PUBLIC HEARING MEMORANDUM

SUBJECT: **Petition #560-22**, for SPECIAL PERMIT/SITE PLAN APPROVAL to subdivide the current lot into two, with one single-family dwelling each at 19 Staniford Street, Ward 4, Newton, on land known as Section 41 Block 31 Lot 21, containing approximately 25,366 sq. ft. of land in a district zoned SINGLE RESIDENCE 3. Ref: 7.3.3, 7.4, 3.1.5, 3.1.10, 1.5.6, 3.1.10.B.3.a of Chapter 30 of the City of Newton Rev Zoning Ord, 2017.

MEMORANDUM

**SITE PLAN
SHOWING PROPOSED TWO NEW SINGLE FAMILY
HOUSES ON PROPOSED LOTS 14A AND 14B
PROPERTY KNOWN AS # 19 STANIFORD STREET
NEWTON, MASSACHUSETTS**

Existing site conditions

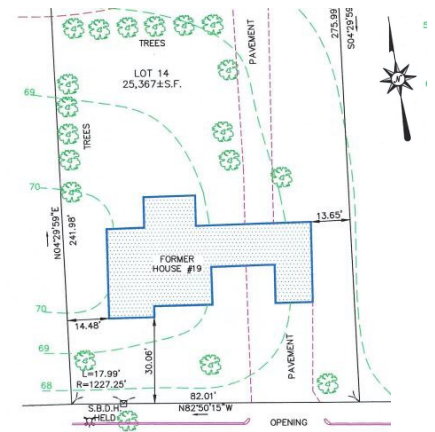
risk FEMA flood zone (the AE zone) and is subject to conservation restrictions. A larger portion of the rear of the lot lies within the 100-foot buffer for a wetland area. Because it appears that some of the proposed development will take place within the wetland buffer area, the petitioner should confirm with Conservation staff to determine whether this project requires review by the Conservation Committee.

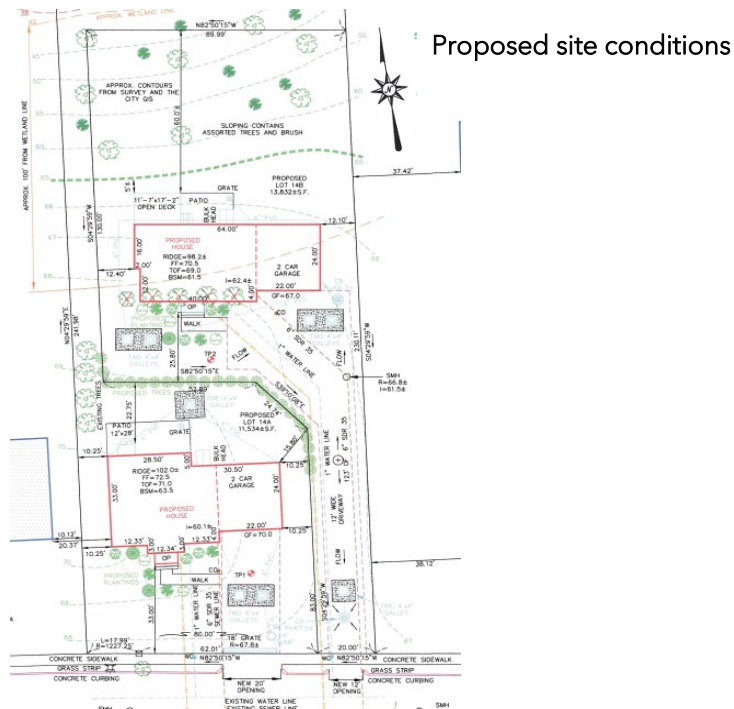
Section 3.1.10.B.2 requires both the front and rear lots to meet the frontage requirements for new lots in the zoning district. The front lot has 80 feet of frontage, where a minimum of 80 feet is required. The rear lot gains its frontage from the rear lot line of the front lot, which is compliant at 88.88 feet.

The project requires relief for both lots to exceed the maximum build factor, which establishes a threshold to limit irregularity in the shape of new lots. This is determined by a formula which identifies a “build factor,” with a higher build factor corresponding to higher irregularity in lot shape. After subdivision, the front lot has

a build factor of 54.9 and the rear lot has a build factor of 20.8. A special permit is required to exceed the maximum build factor of 20 on any lot in the SR3 district. The proposed configuration is such that the lot is divided where the front lot maintains an irregular shape as it runs the entire length of the two lots along the western lot line with additional land at the rear of the site.

The petitioner proposes to utilize the Alternate Side Building Separation dimensions for the rear lot. This requires that the proposed structure be 10 feet from the side lot lines, with a minimum of 30 feet of separation between the proposed dwelling and the abutting dwelling structure. There is over 50 feet of separation between the proposed single-family dwelling on the rear lot and the existing dwellings on the abutting properties on each side, with a proposed side setback from the lot line of 12.4 on the western side lot line and 12.1 on the eastern. No relief is required for those setbacks.

The proposed dwelling on the front lot meets all required minimum setbacks for the SR-3 district. Because the dwelling on the rear lot is situated 25.8 feet from the rear lot line of the front lot where 30 feet is required, a special permit is required.
